Product Change Notification

Change Notification #: 113287 - 00
Change Title: Intel® Server System R2308GZ4GS9
PCN 113287-00, Product Design
Update the System Rear Panel, 750W Common
Redundant Power Supply , Resistors and
Capacitors
Date of Publication: October 15, 2014

Figure One

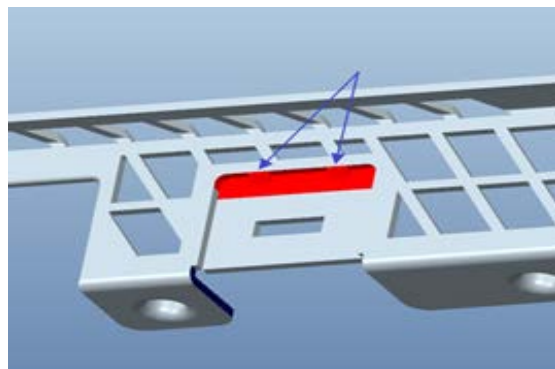
1. Update the one big center joint to two smaller joints so that the joints will not conflict with the LAN cable connector latch. See the Figure One.

Figure Two

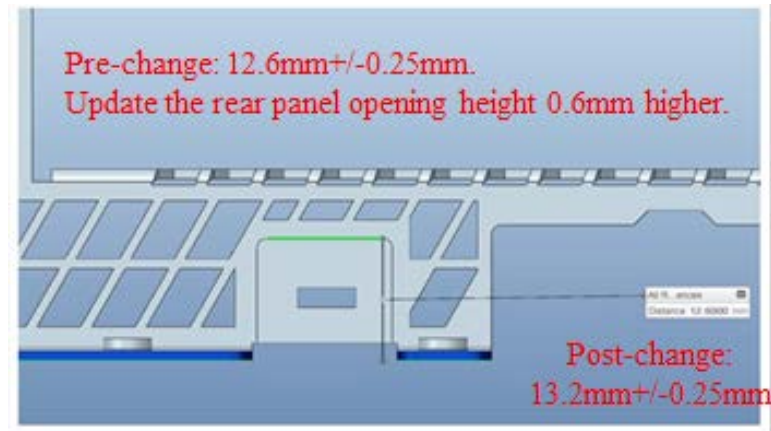
2. Update the rear panel opening height 0.6mm higher to improve the flexibility for the cable latch. The previous height was 12.6mm \pm 0.25mm. The updated height is 13.2mm \pm 0.25mm. See the Figure Two.

Figure Three

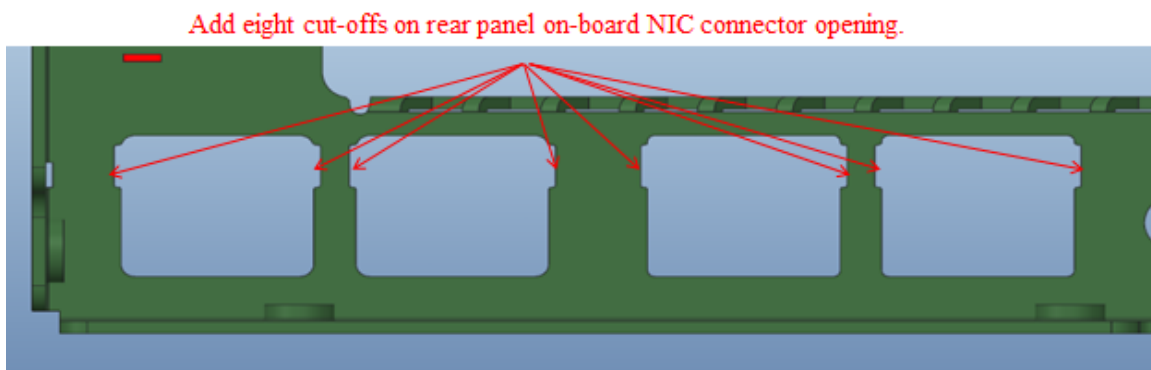
3. Add eight cut-offs around the on-board NIC (Network Interface Controller) openings to improve the LED visibility. See the Figure Three.

Figure Four. Component Locations for the 2U Riser Spare A2UL8RISER

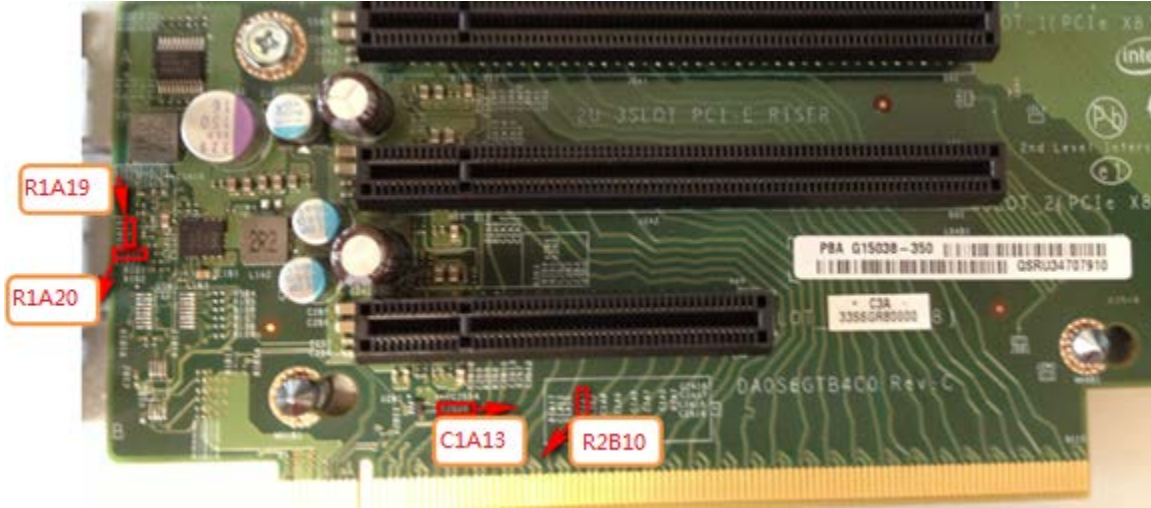
5. Update the following resistors and capacitor (see Table One and Figure Four) on the 2U PCIe Riser Spare A2UL8RISER to make an improvement to support a higher 3.3 Voltage Regulator startup over current. Before this change, the Voltage Regulator on the riser card may not be able to turn on when the total current drawn is more than 5A current. After this change, the Voltage Regulator on the riser card can support more than 10A current.
